# MEMORANDUM

**DATE:** February 19, 2019

**SUBJECT:** RONDOUT RIVERPORT SHORELINE STABILIZATION AND PUBLIC ACCESS  
**Re: Sea Level Rise and Design Elevation Standards**

# FIGURE 1

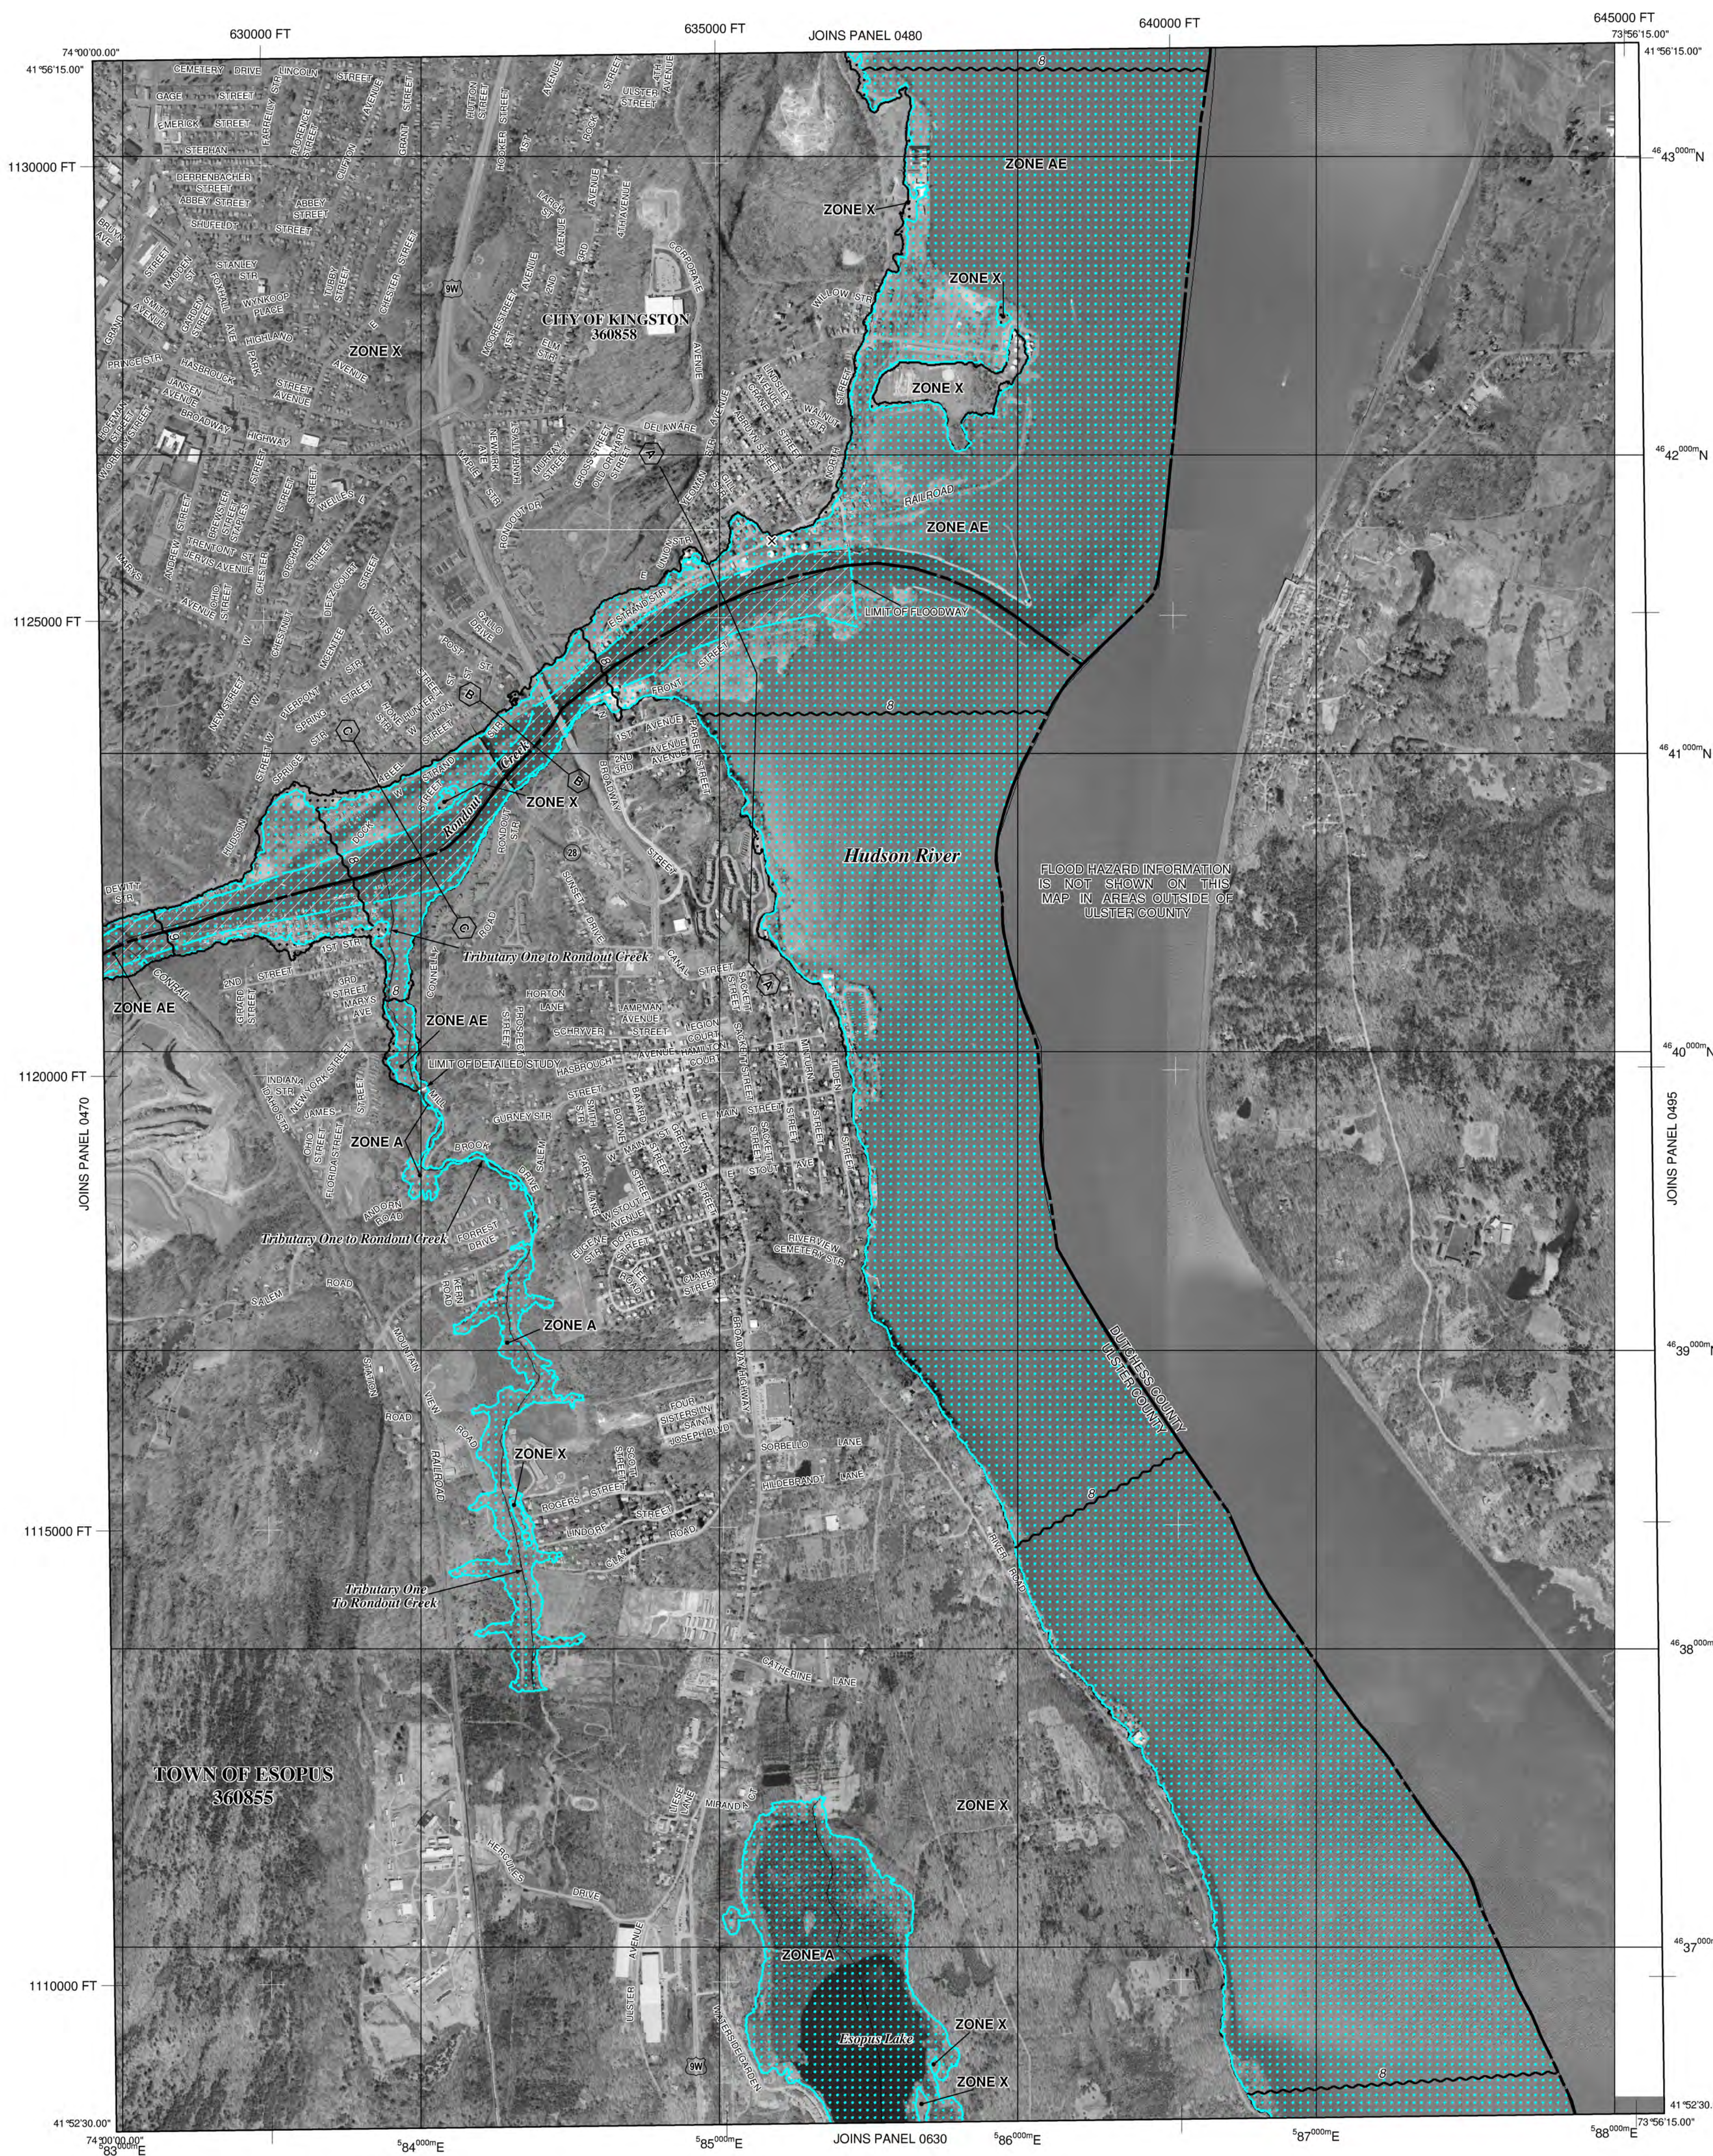
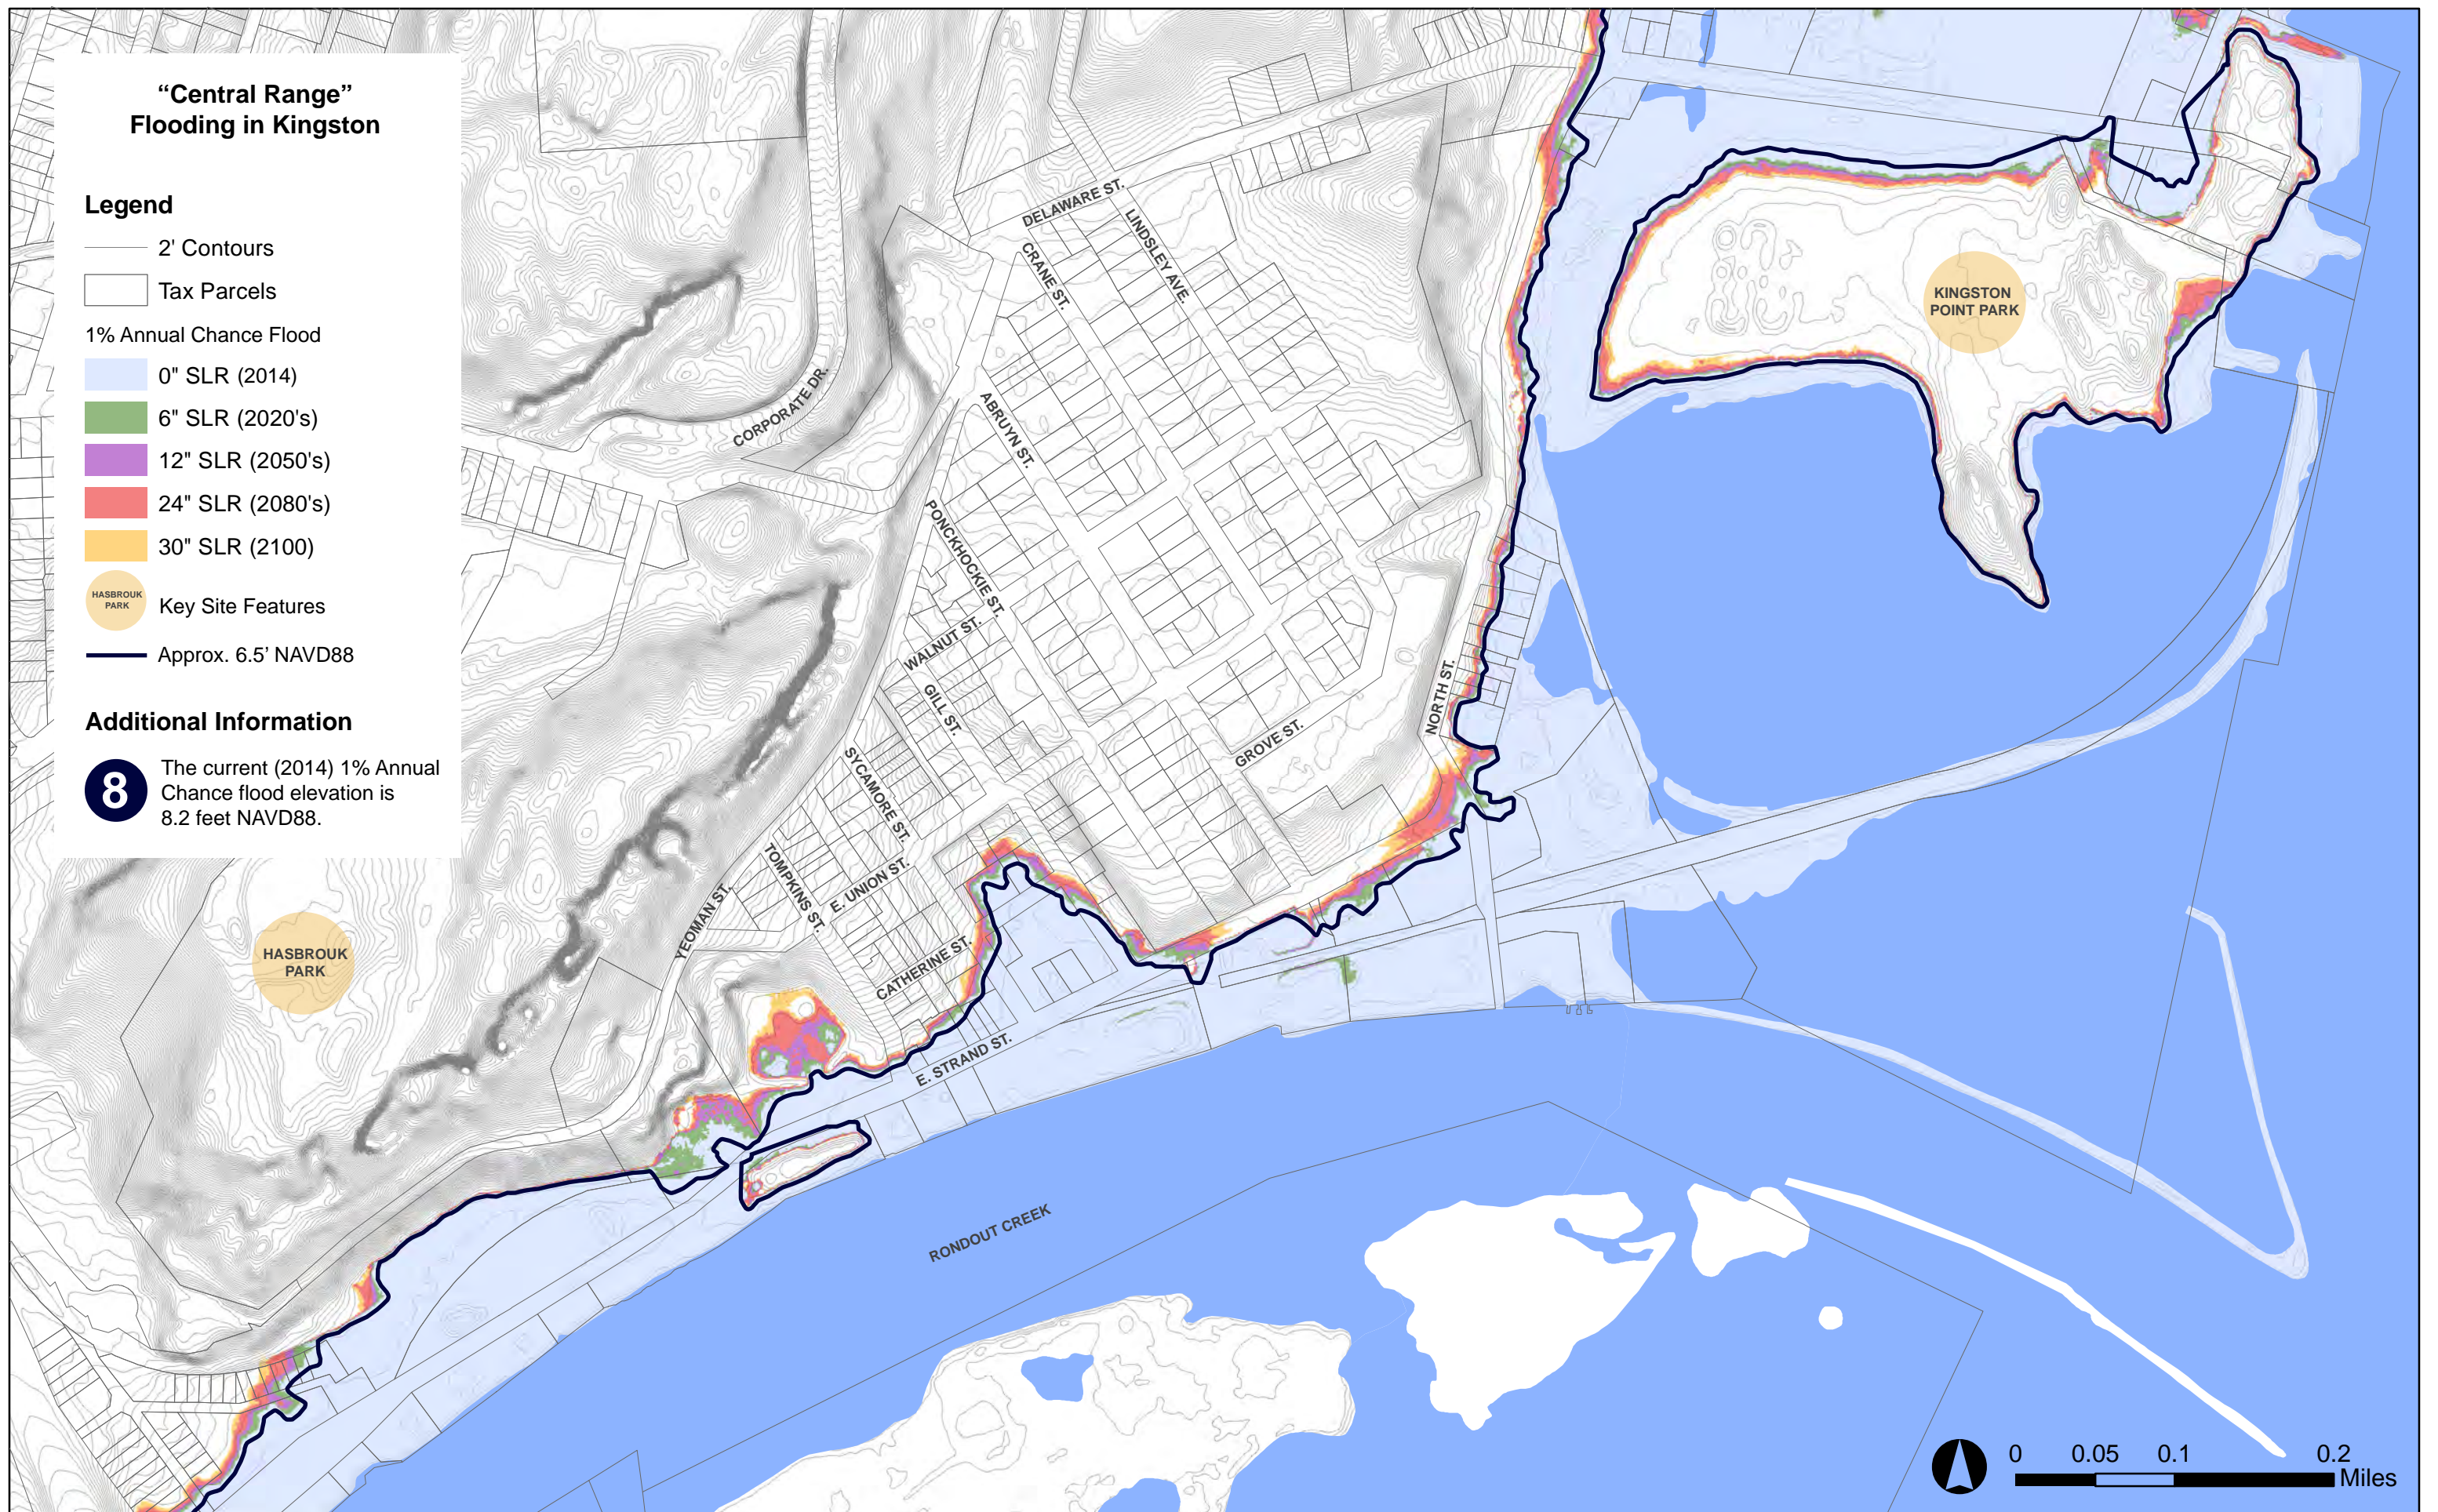
The design criteria selected by the City for this project includes an increase in elevation up to El. 6.5 feet (North American Vertical Datum of 1988 (NAVD88)) and a 35-year design life. These criteria are also being used at an adjacent site for a project by the McLaren Engineering Group. However, this elevation is below the elevation of the current 1% Annual Chance Flood at the project site, which is approximately El. 8 feet NAVD88 as documented by FEMA on the effective Flood Insurance Rate Map (FIRM).

The Rondout Riverport Shoreline Stabilization and Public Access project site falls within FEMA Zone AE. This zone is included within the Special Flood Hazard Area (SFHA), which shows the extent of the 100-year flood, otherwise known as the 1% Annual Chance Flood. Zone AE also includes Base Flood Elevations (BFEs) showing the anticipated height of the 1% Annual Chance Flood. The FEMA-defined BFE indicated for the project site is 8 feet NAVD88. Please refer to **Figure 1** for a copy of the FEMA FIRM and BFEs near the project site.

Incorporating climate resilience into design can help mitigate these impacts. ***At a minimum, it is recommended that the project should be designed to El. 10 NAVD88 (the current BFE plus 2 feet of freeboard). We recommend incorporating 36 inches of SLR into the design to achieve a design life of 35 years based on currently available data.***
